Village of Grantsburg

Village Board Meeting Agenda Monday, February 9, 2026 at 4:00 p.m. Village Board Room, 316 S. Brad Street

RE: Change Order 01
Village of Grantsburg
Grantsburg WWTP Improvements
SEH No. 184139 71.50

Change Order No. 1 to the Grantsburg WWTP Improvements project is enclosed. This Change Order includes six (6) items previously approved as individual line items by the Village Board and two (2) items that have not been approved. SEH recommends approval of Change Order No. 1 to incorporate the following changes into the Contract with Market & Johnson, Inc. (Contractor):

THIS BAR IS INTENDED TO BE 1\"/>

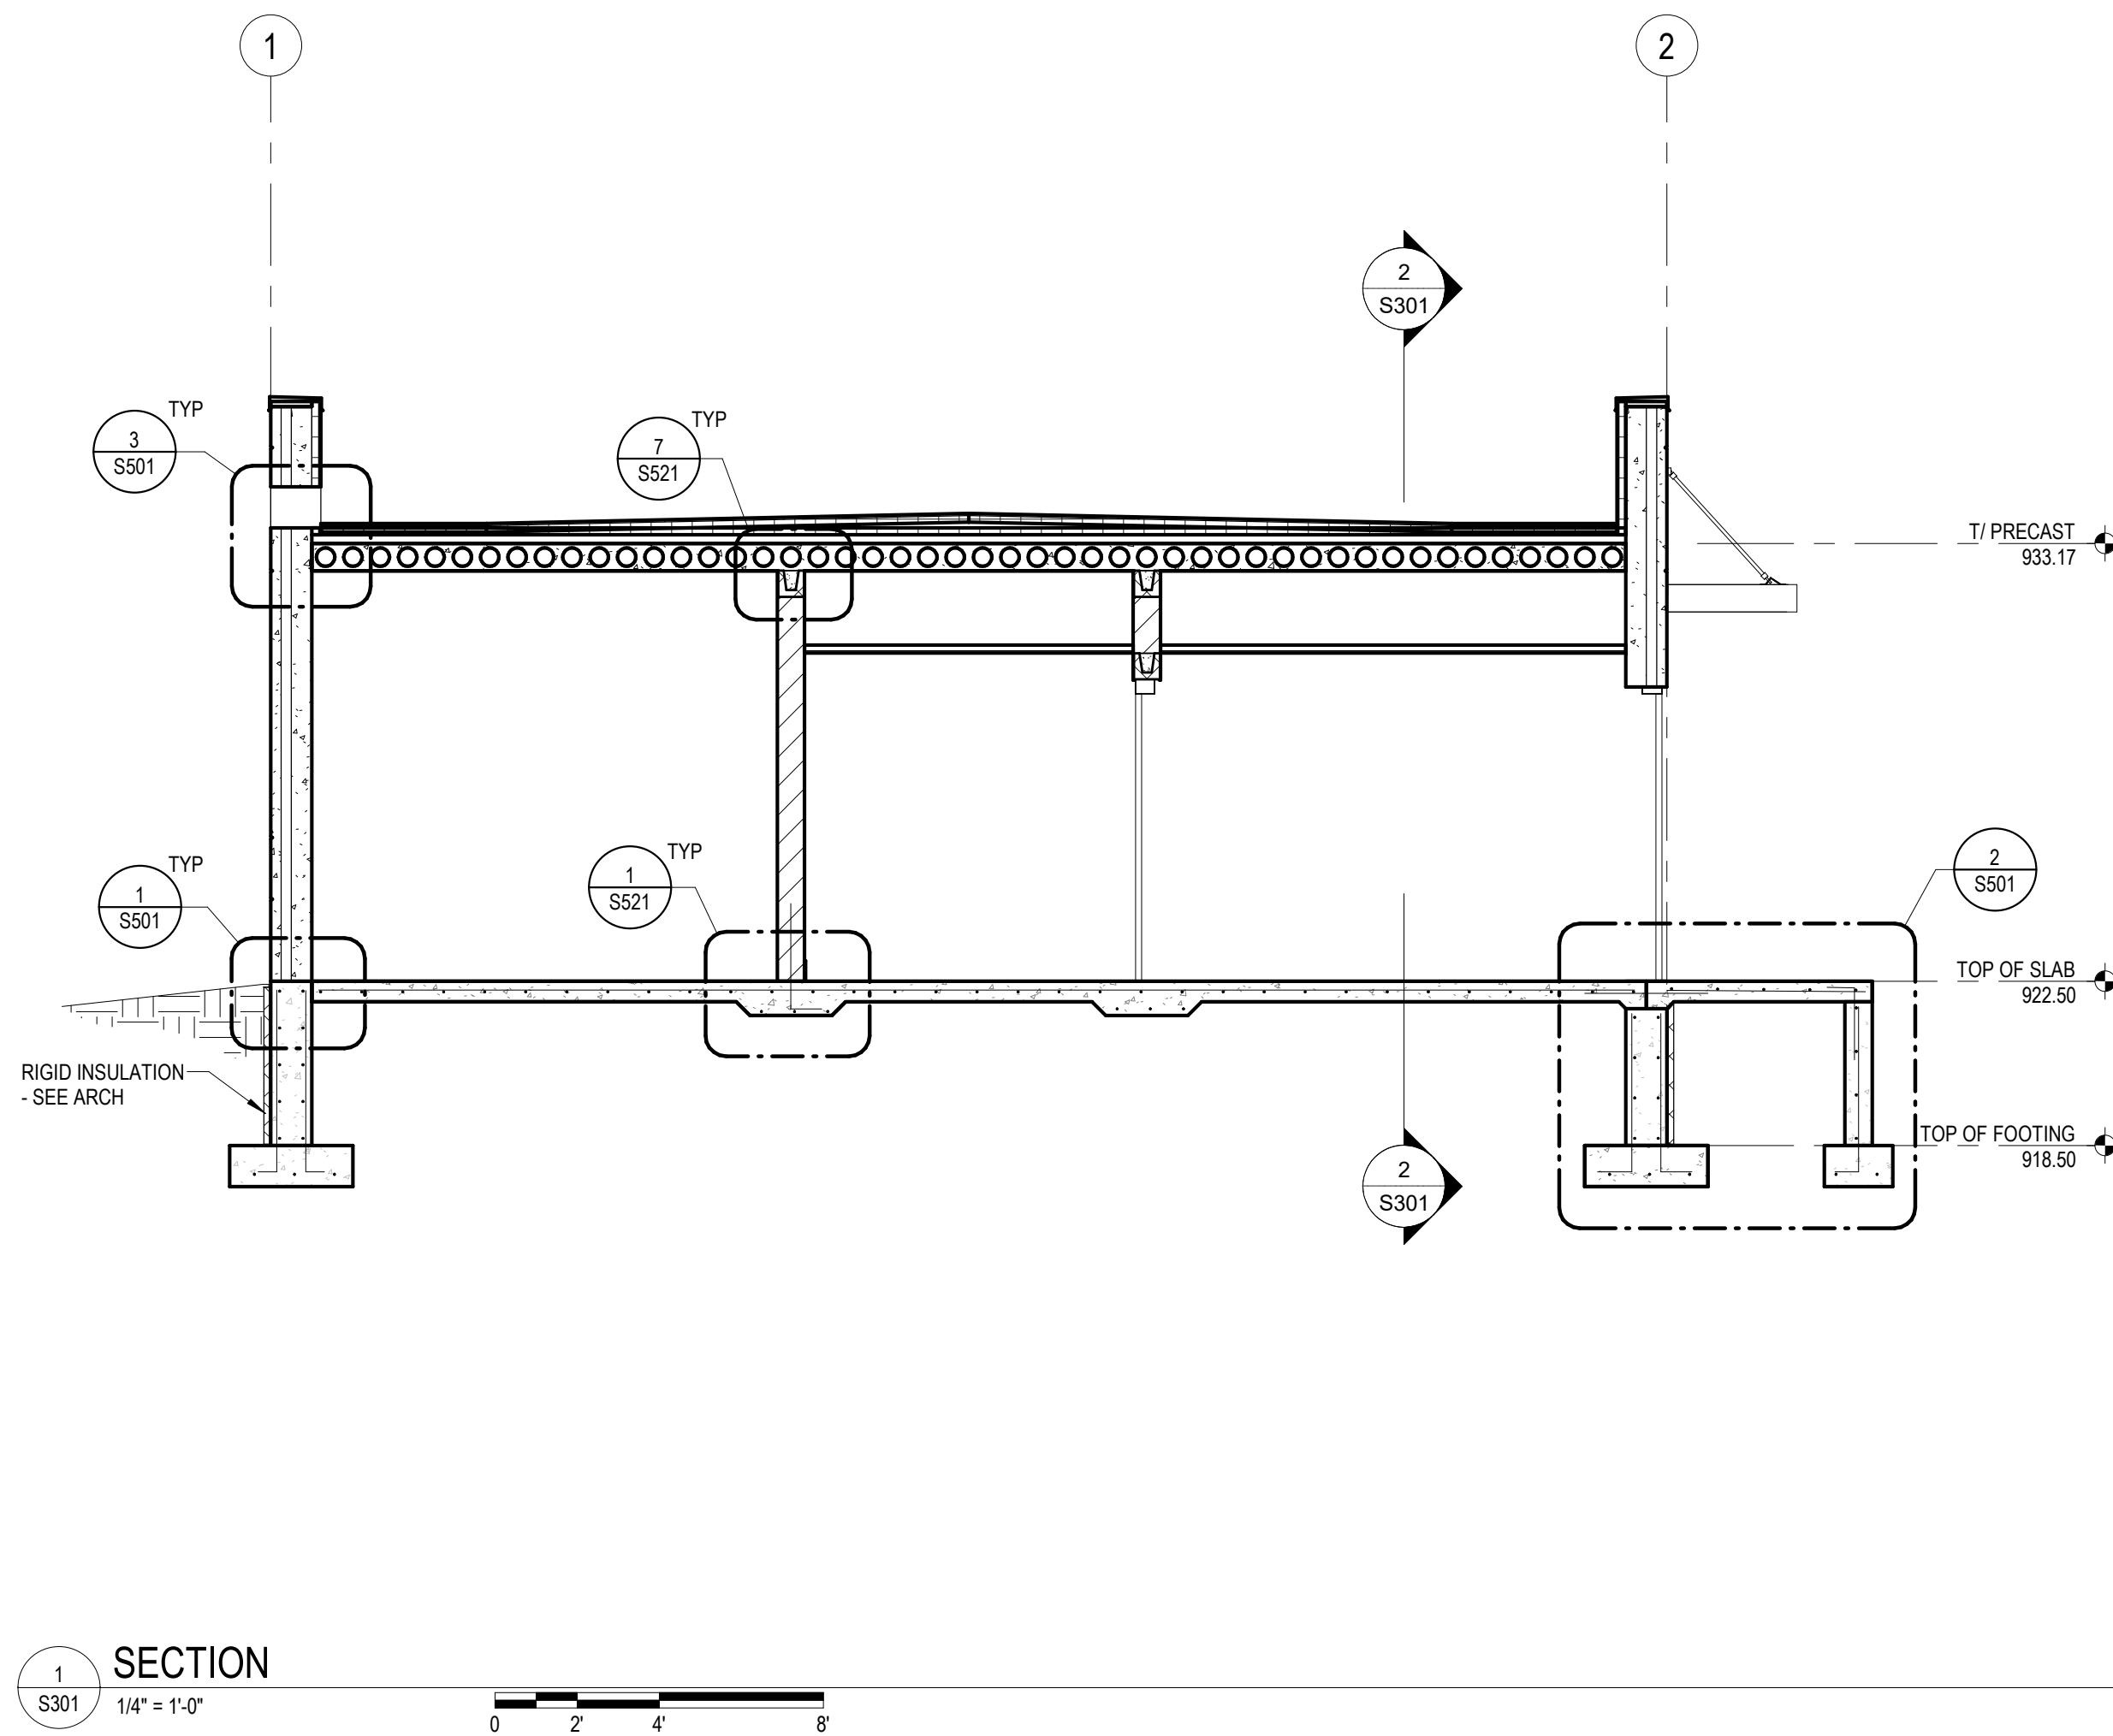
This Construction Bulletin (CB-01) documents drawing revisions and clarifications identified during the structural shop drawing reviews (rebar and precast). These changes were noted on the returned shop drawings and consolidated here for the record.

The purpose of this Construction Bulletin is to formally communicate several drawing changes associated with discrepancies discovered during the structural shop drawing reviews for rebar and precast. These drawing changes/clarifications have already been communicated on the returned shop drawings. No cost changes associated with this Construction Bulletin.
